From: [REDACTED]
To: [David Loya](#)
Subject: Gateway Area Plan
Date: Tuesday, April 16, 2024 9:06:32 PM

From: [REDACTED]
To: [Meredith Matthews](#); [Stacy Atkins-Salazar](#); [Alex Stillman](#); [Kimberley White](#); [Sarah Schaefer](#); [Scott Davies](#); [Dan Tangney](#); [Matthew Simmons](#); [Peter Lehman](#); [Joel Yodowitz](#); [Abigail Strickland](#); [Millisa Smith](#); [David Loya](#); [Jennifer Dart](#); [Karen Diemer](#)
Subject: from Fred Weis: Gateway Code - Comments and suggestions
Date: Friday, April 19, 2024 9:38:24 AM
Attachments: [Gateway-Code-Comments_Fred-Weis_April-18-2024-v10.pdf](#)

The attached document includes my comments and suggestions for improvements to the Gateway Code. I composed this document so that we could create a better Gateway Code for Arcata.

Also known as the form-based code for the Gateway Area Plan

Figure 2-28: G-B District Building Massing

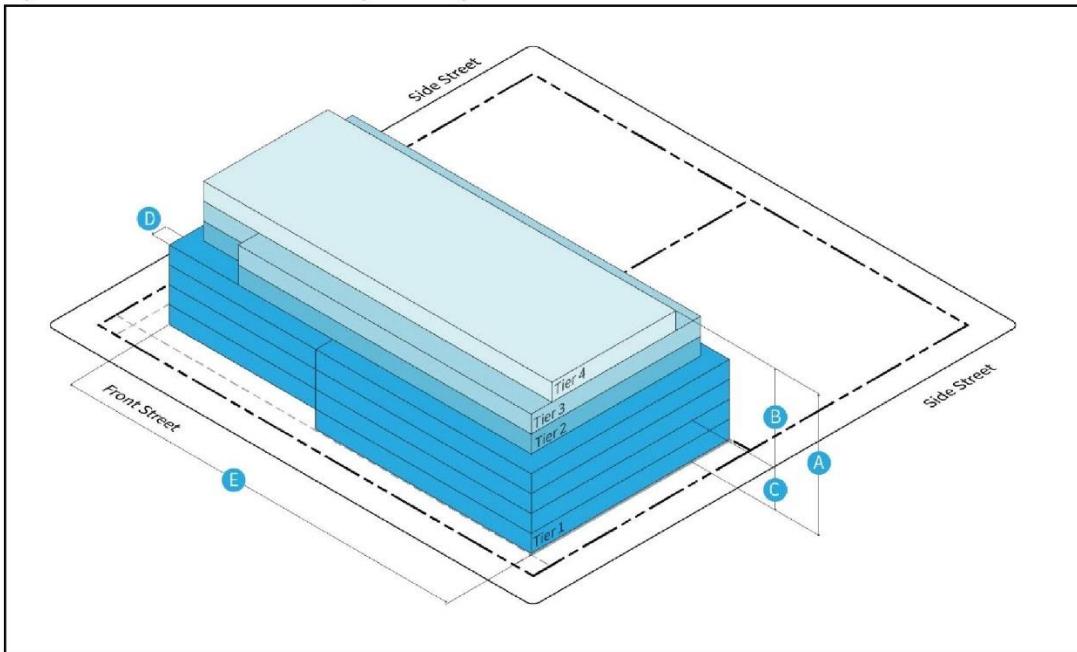
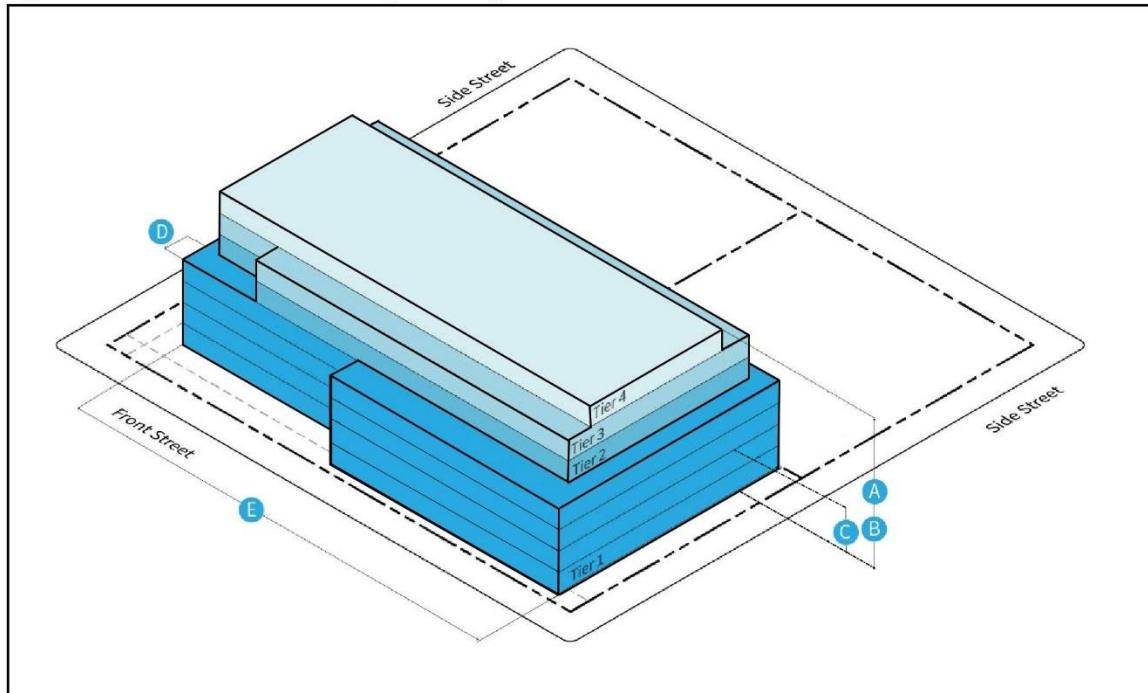
First, the original. The left side of the building looks as though it could be floating.

The improved drawing, below. Measurement depictions for B, C, and D are improved also.

Note: This drawing was derived from the existing drawing, to show what an improved isometric drawing could look like. The upper-story stepback depth is increased, and the street setback is decreased — so the setback from the street is not accurate. To be used in the Gateway Code, this figure would need to be re-drawn.

Figure 2-28: G-B District Building Massing

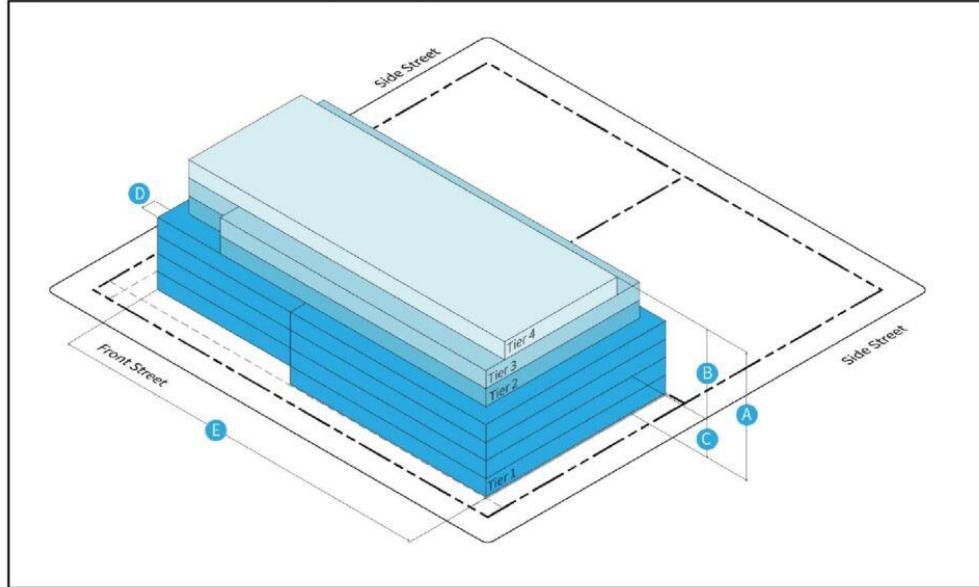
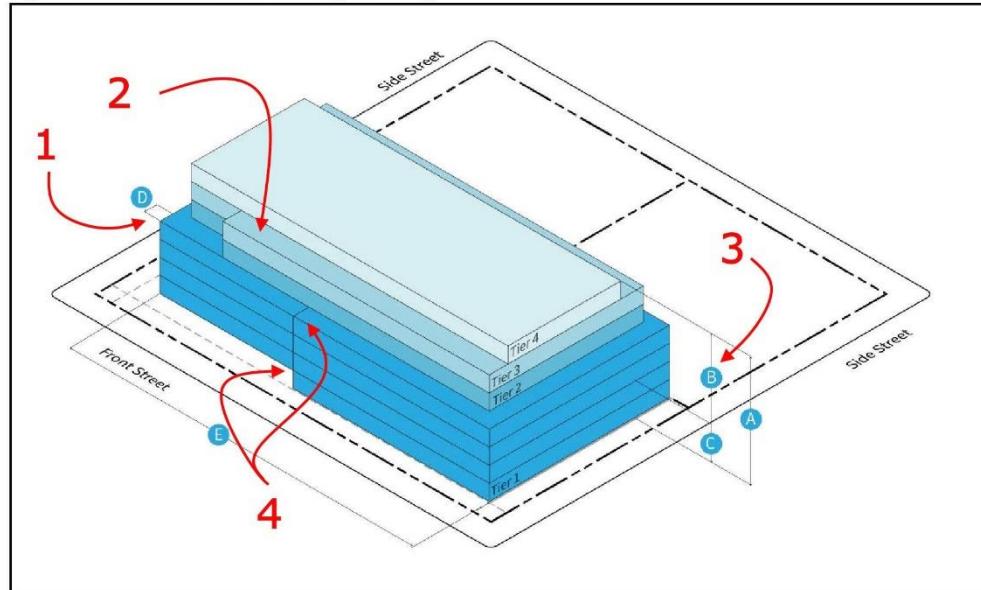
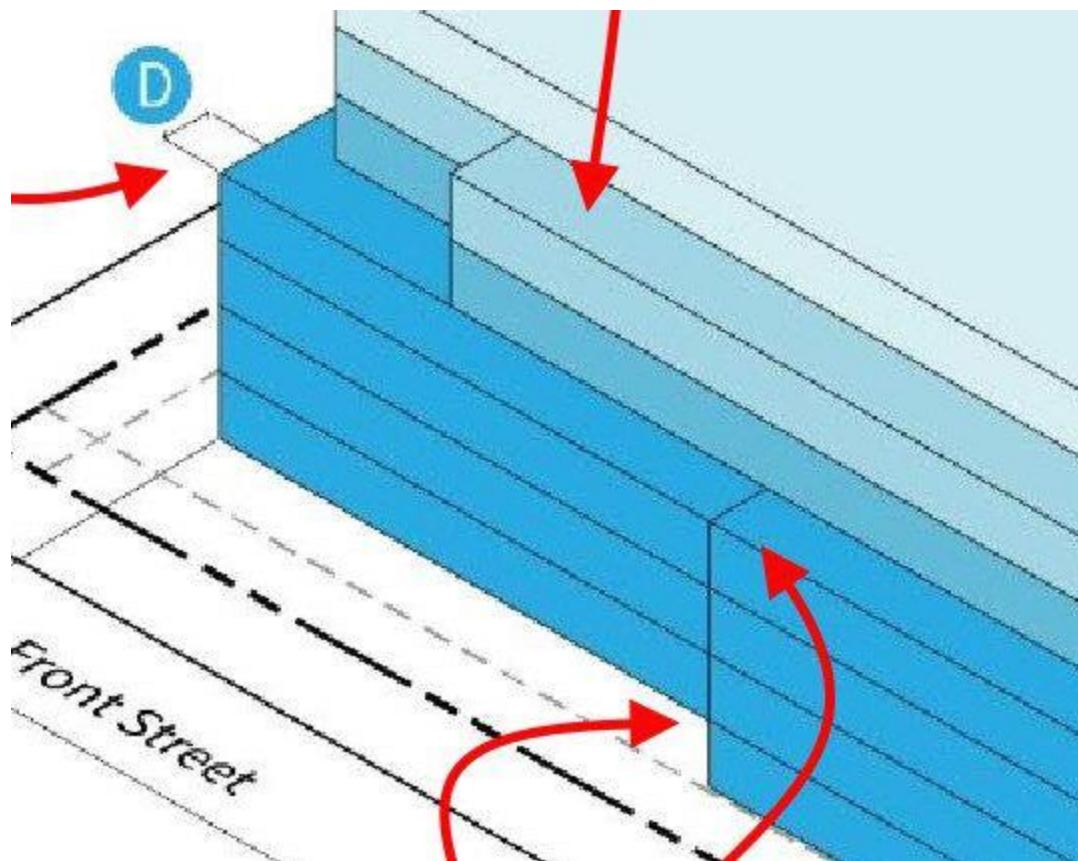
1. The image “Figure 2-28: G-B District Building Massing” shows no change from the June 5 draft. It shows a step-back on the 7th story (Tier 4). In the form-based code, there is no step-back specified for the 7th story.

I believe these drawings should be improved. As an isometric drawing that is intended to convey information, it rates a B-, or C+. This is what's wrong:

- 1– The width of dimension “D” does not match the width of the step-back that it’s intended to illustrate.
- 2– It is showing a second upper-story step-back, with the 7th story (Tier 4). In the form-based code, there is no step-back specified for the 7th story.
- 3– It shows the maximum height as “B” stacked over the minimum height “C” — It’s not clear whether B is the added height. B should instead be placed in the same height-line as A.
- 4– In the isometric drawing, the lines showing the depth of the step-back exactly match the lines that show the height of each floor. The coincidence of the step-back width matching the floor height lines makes for a drawing that cannot easily be understood — it’s like an optical illusion. This is a poor choice on the part of the person who made the drawing, and one that is very easily corrected. A closeup is below.

Figure 2-28: G-B District Building Massing

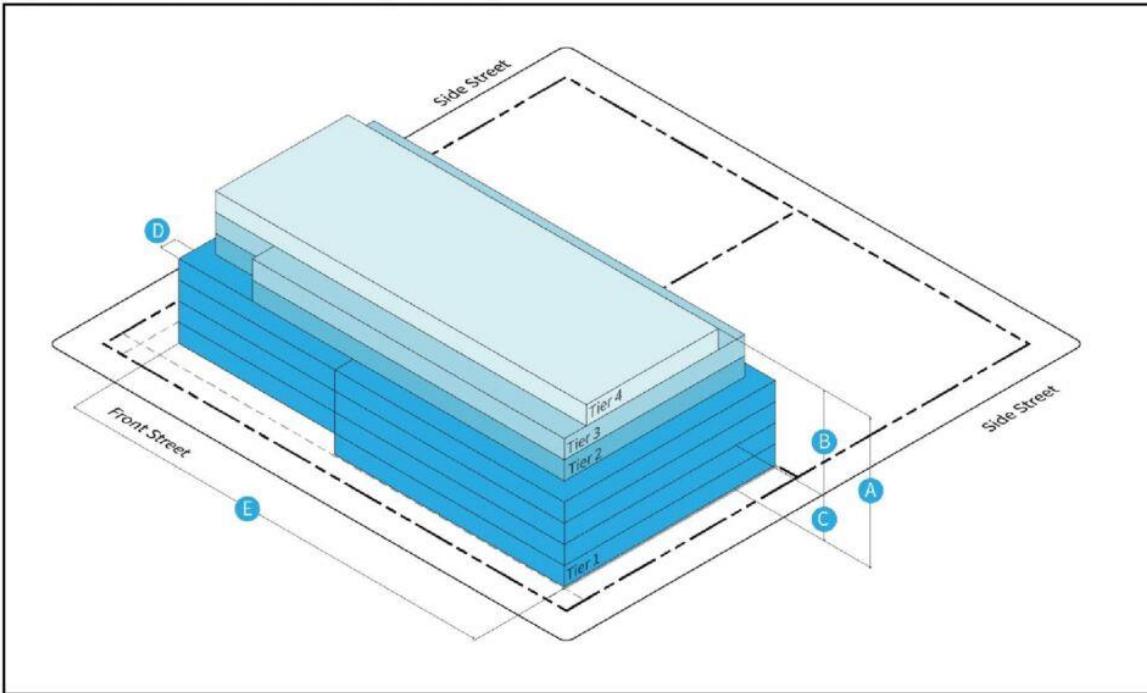
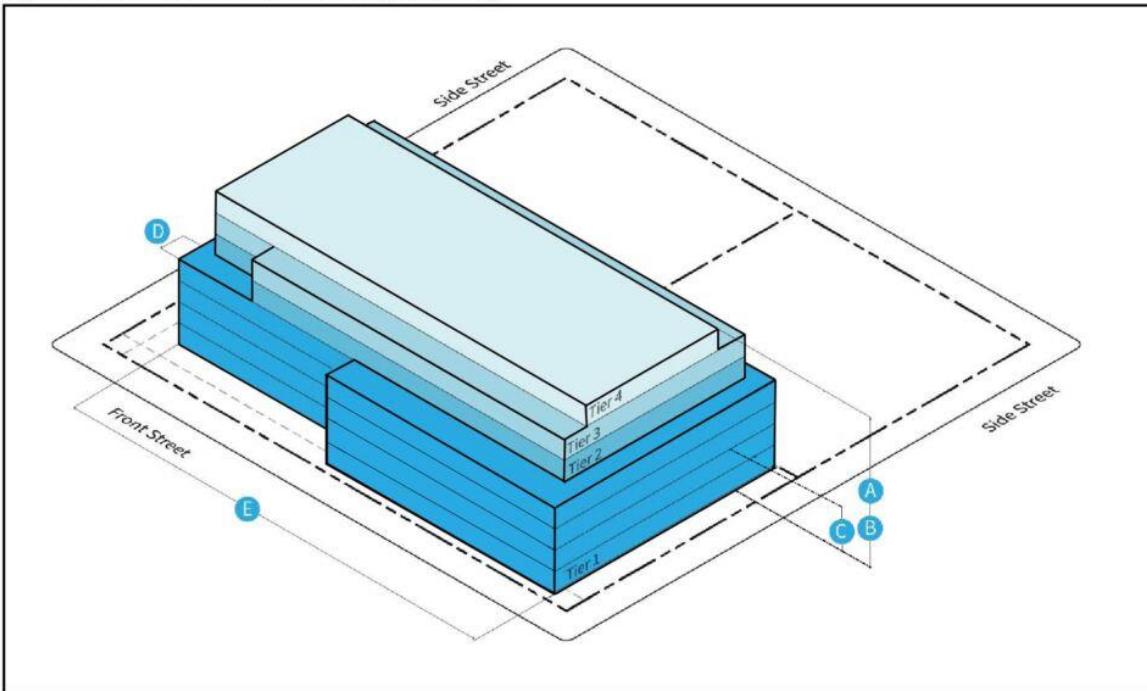
Here is an improved drawing. It is not perfect, but is far easier to read and obtain information from than the original drawing. First, the original. The left side of the building looks as though it could be floating.

The improved drawing. In this drawing the step-back depth is increased, and the street setback is decreased — so the drawing is not accurate. It was derived from the existing drawing, to show what an improved isometric drawing could look like. Measurement depictions for B, C, and D are improved also.

Figure 2-56: Conceptual Greenway Configuration

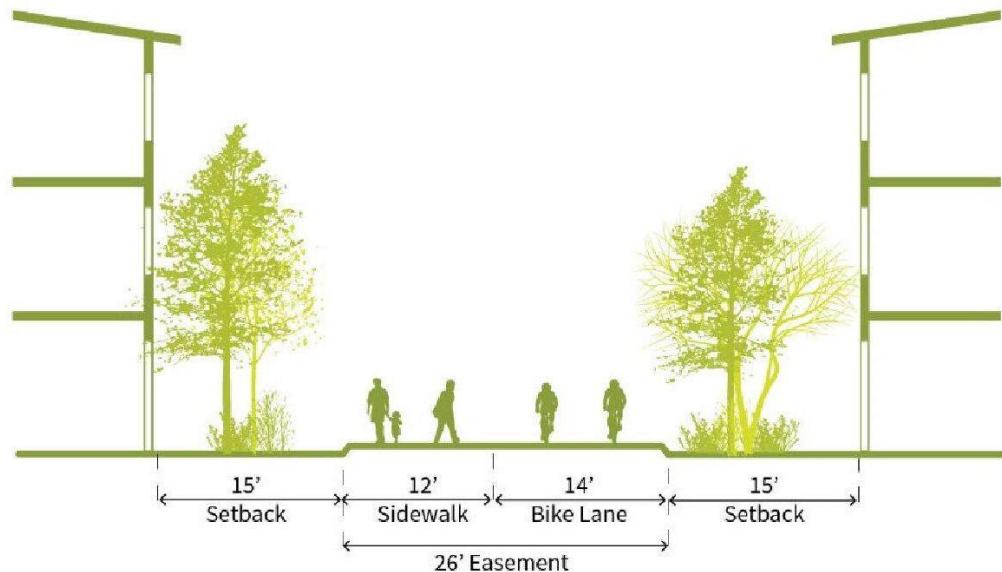
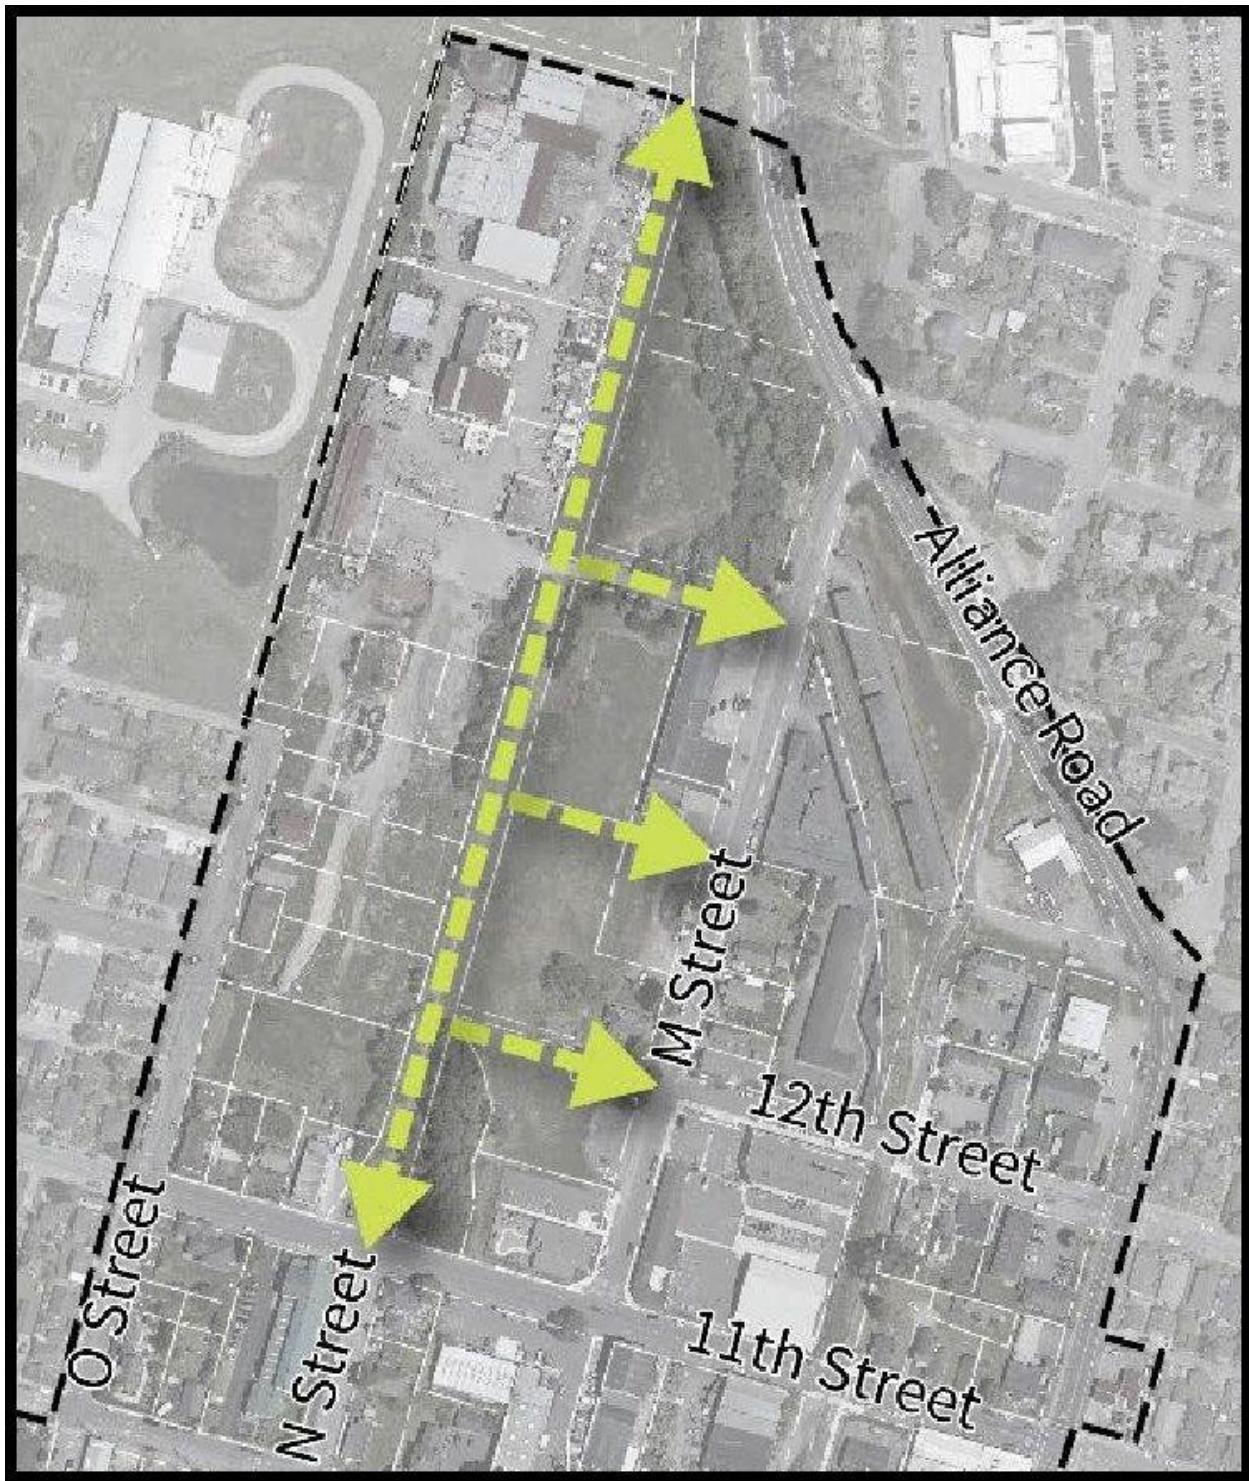
In the larger image of the greenways, we see there are five or six greenway routes shown in the Barrel district on what is private property. We want the master plan for the Barrel district property to include some trails and greenway routes — but it would need to be coordinated with the proposed vehicle roads and other open space in those parcels.
